STONEBOROUGH 2ND ADDITION

WICHITA, SEDGWICK COUNTY, KANSAS

RE: S/D 99-70 -- One-Step Final Plat of STONEBOROUGH 2ND ADDITION

STAFF REPORT
(One-Step Final Plat Approved 11/4/99)

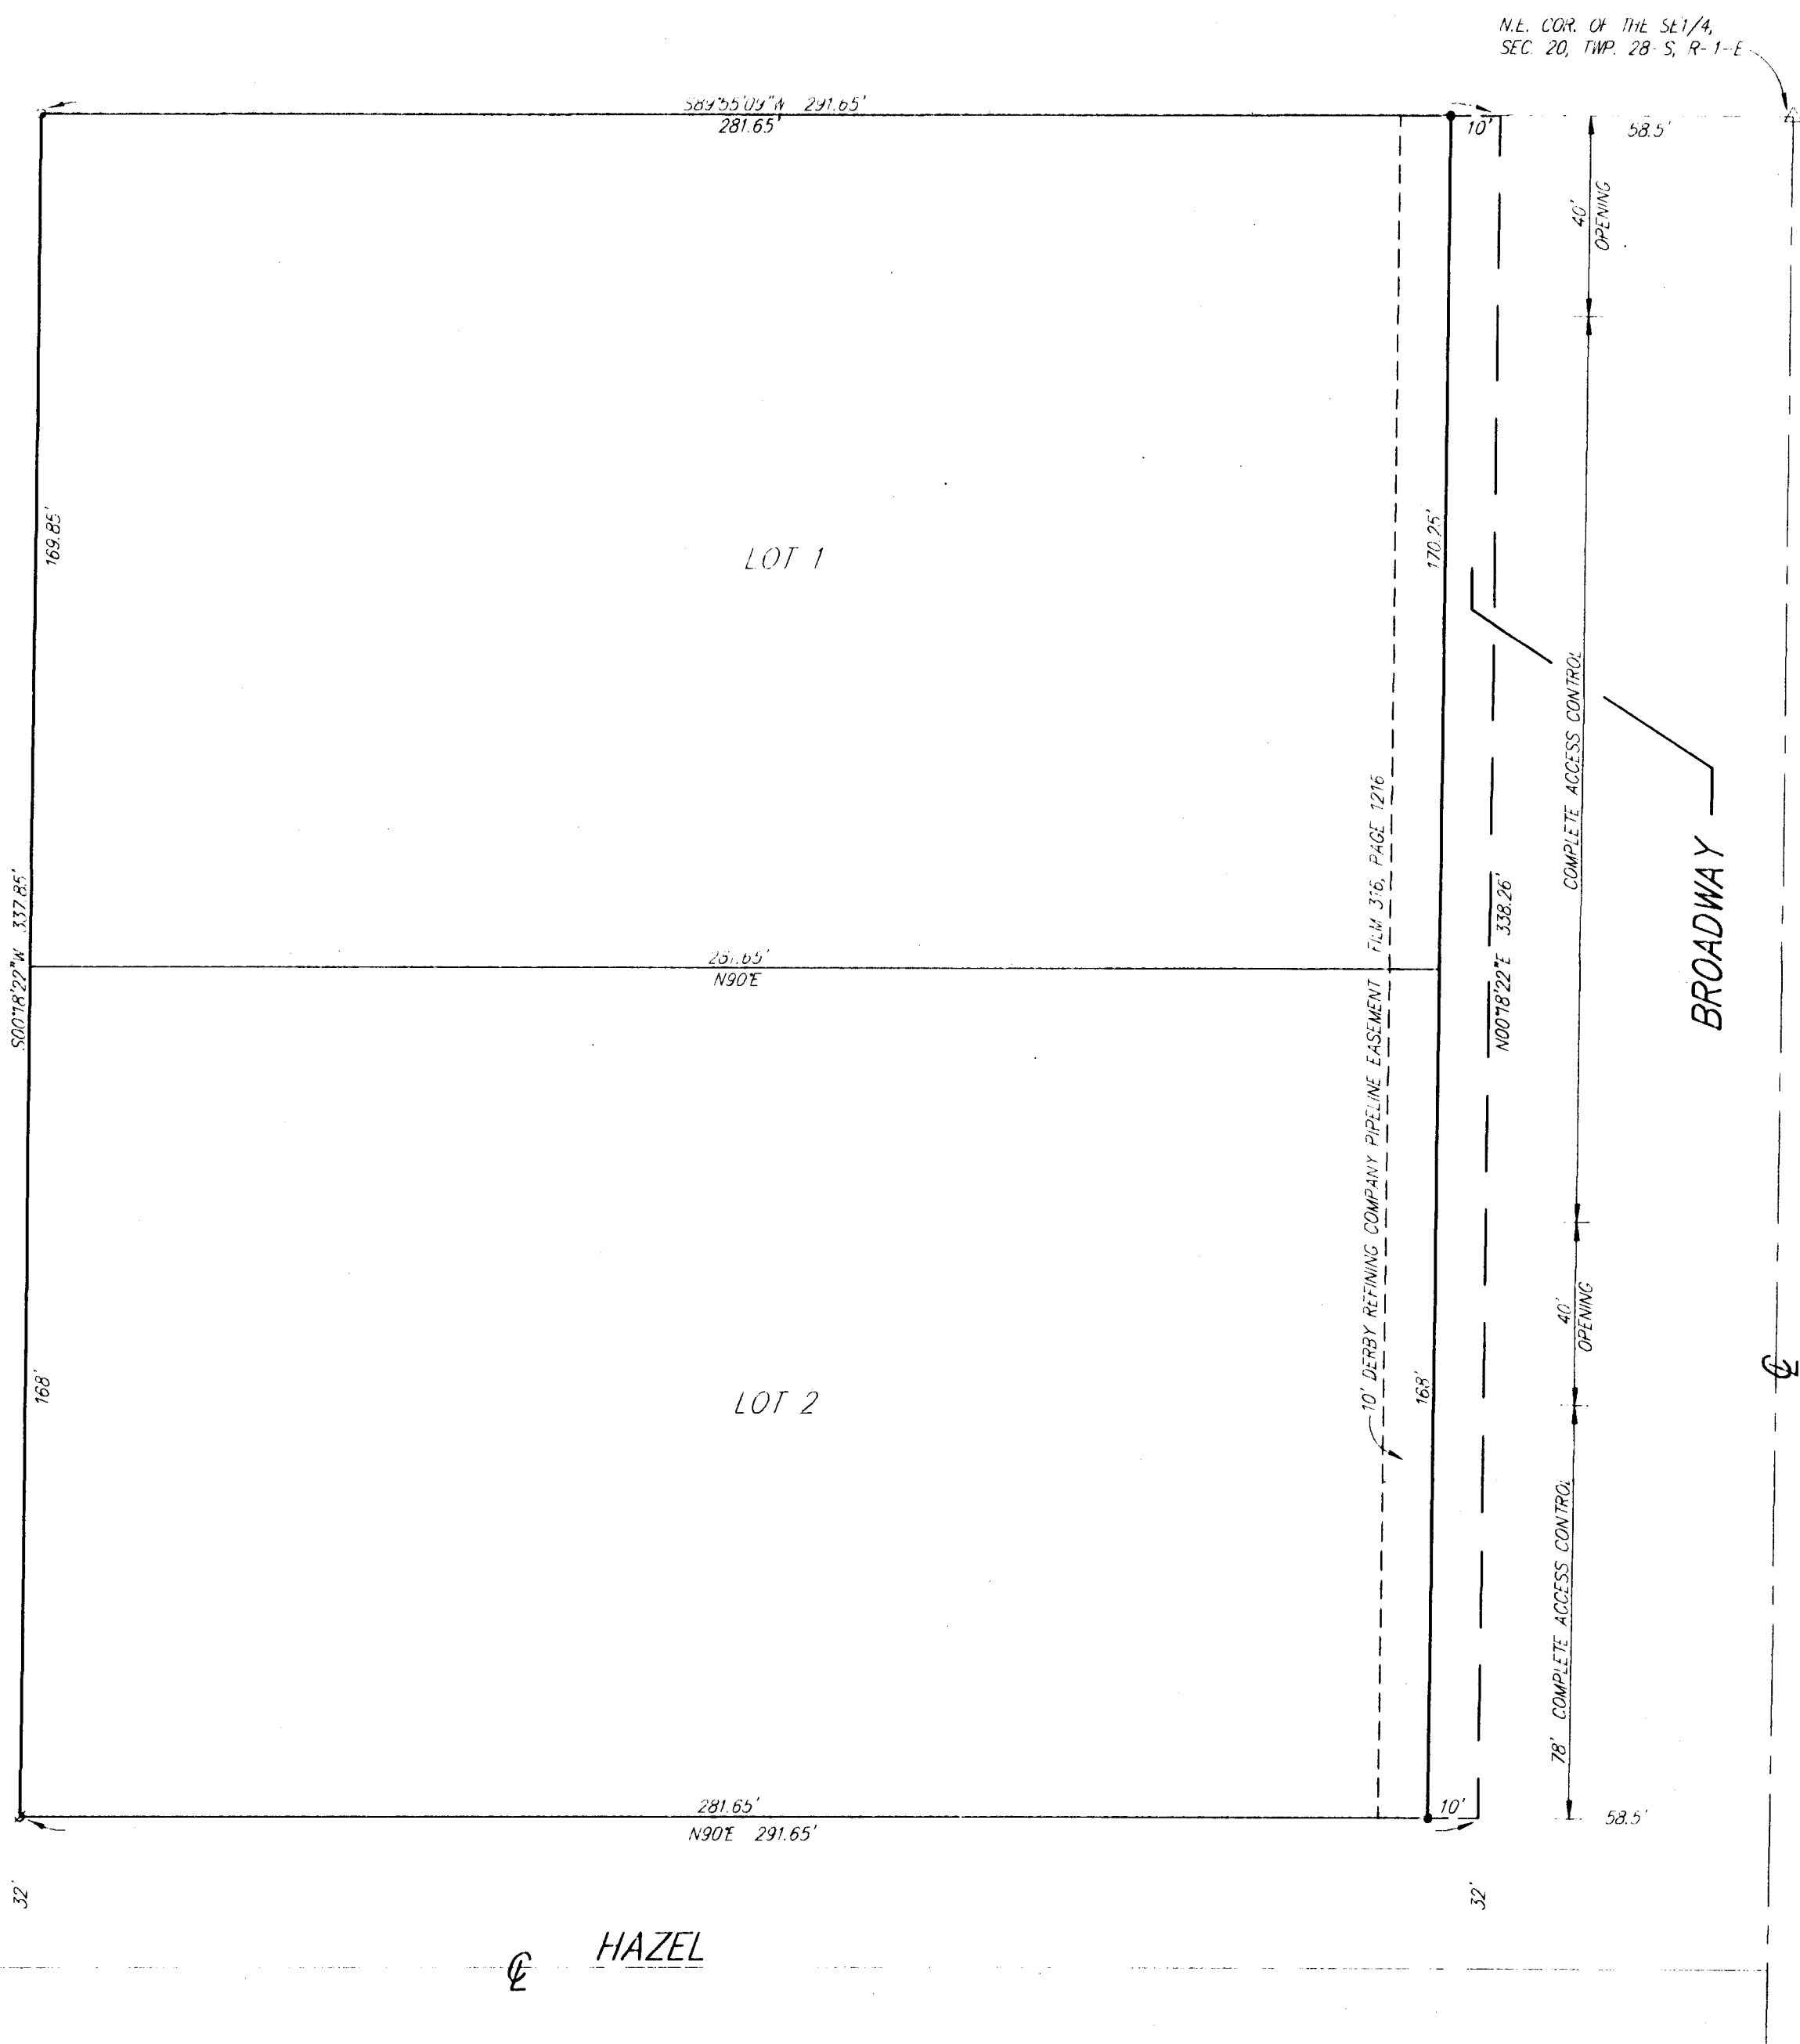
- A. Two openings are permitted; one opening to be located along the north property line to allow for possible future shared access with the adjoining property to the north, the south opening to be located in alignment with the existing opening across Broadway to the Colonial Heights Addition.
- B. The applicant shall dedicate 10 feet of additional right-of-way along Broadway.

- D. Traffic Engineering needs to comment on the access controls. The plat proposes three access openings along Broadway, including one joint access. Distances should be shown for all segments of access control. Traffic Engineering has approved one access opening per lot. The Subdivision Committee has approved the plat with two openings subject to concurrence by KDOT.

- ✓ E. The MAPC signature block should be revised to reference "Francis S. Garofalo" as the MAPC Chairman.

- G. The applicant's agent shall determine any setback requirements for the pipelines by researching the text of the pipeline agreements. If a setback from the pipeline easements is provided for in the pipeline easement agreements, it shall be indicated on the face of the plat.

- I. The dimension along the north line of the plat needs to be revised to correspond with the legal description.
- J. The plat's text shall include language that a drainage plan has been developed for the plat and that all drainage easements, rights-of-way, or reserves shall remain at established grades or as modified with the approval of the applicable City or County Engineer, and unobstructed to allow for the conveyance of stormwater.
